Point Beach Nuclear Plant, Units 1 and 2
Dockets 50-266 and 50-301
Renewed License Nos. DPR-24 and DPR-27

Response to Request for Additional Information
License Amendment Request 247
Spent Fuel Pool Storage Criticality Control

RESPONSE TO REQUEST FOR ADDITIONAL INFORMATION LICENSE AMENDMENT REQUEST 247 SPENT FUEL POOL STORAGE CRITICALITY CONTROL

Figure 1 - Axial Burnup Profiles for Fuel Assemblies Containing PPSAs

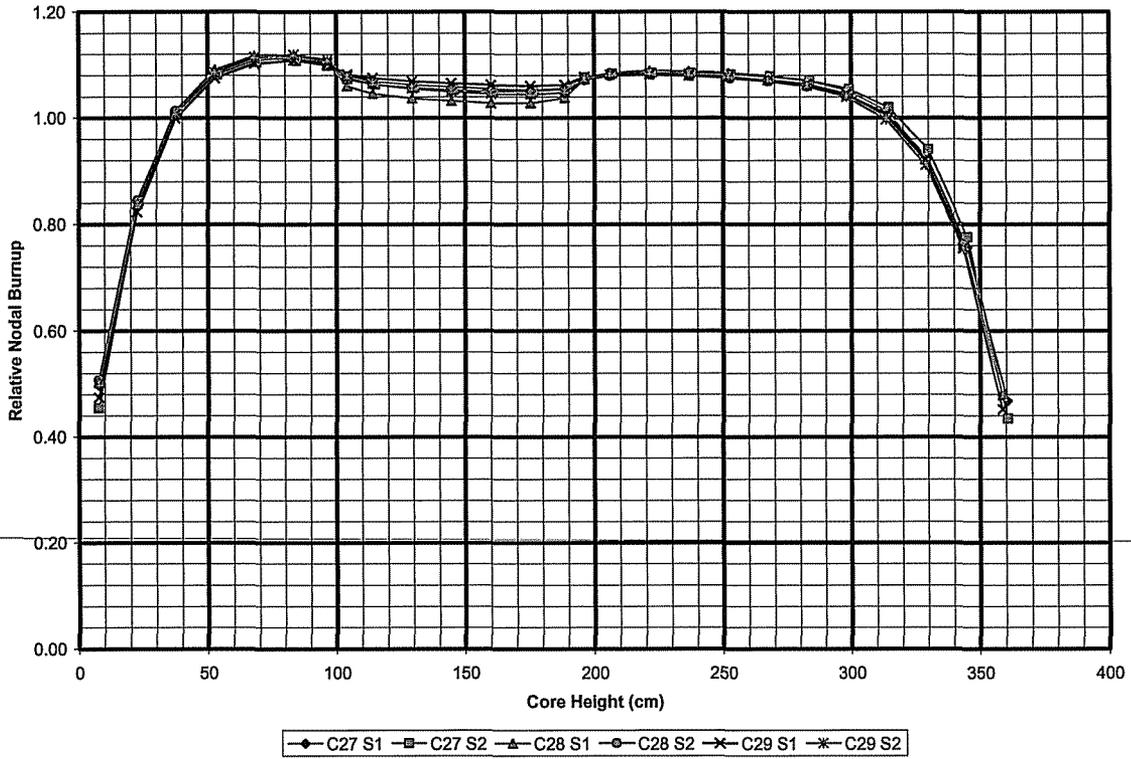
- a) *Please provide a quantitative justification to demonstrate that power suppression assemblies do not result in a more reactive assembly.*

The first step in providing the quantitative justification is a review of burnup profiles for fuel assemblies containing PPSAs for the last several cycles of PBNP Unit 2 operation. The Unit 2 profiles are applicable and representative of both units because the PPSAs have been used with the same strategies in both units. Six unique burnup profiles from assemblies containing PPSAs in Unit 2 Cycles 27 – 29 are presented in Figure 1.

Examination of Unit 2 burnup shapes in the context of PPSAs yields two potentially limiting profiles; Cycle 27 Shape 2 (C27 S2) and Cycle 28 Shape 1 (C28 S1). The C27 S2 profile is selected because it has the lowest relative burnup at the top of the assembly and is expected to have the most limiting, or highest, end effect reactivity of these assemblies. The C28 S1 profile is selected because it exhibits the largest local relative burnup suppression from PPSA use. Both fuel assemblies were discharged after four cycles of operation. The C27 S2 assembly contained a PPSA for its final cycle of operation and was discharged with a burnup of 56,553 MWd/MTU. The C28 S1 assembly contained a PPSA for its last two cycles of operation and was discharged with a burnup of 48,632 MWd/MTU. The PPSA exposure for this assembly bounds others in the population.
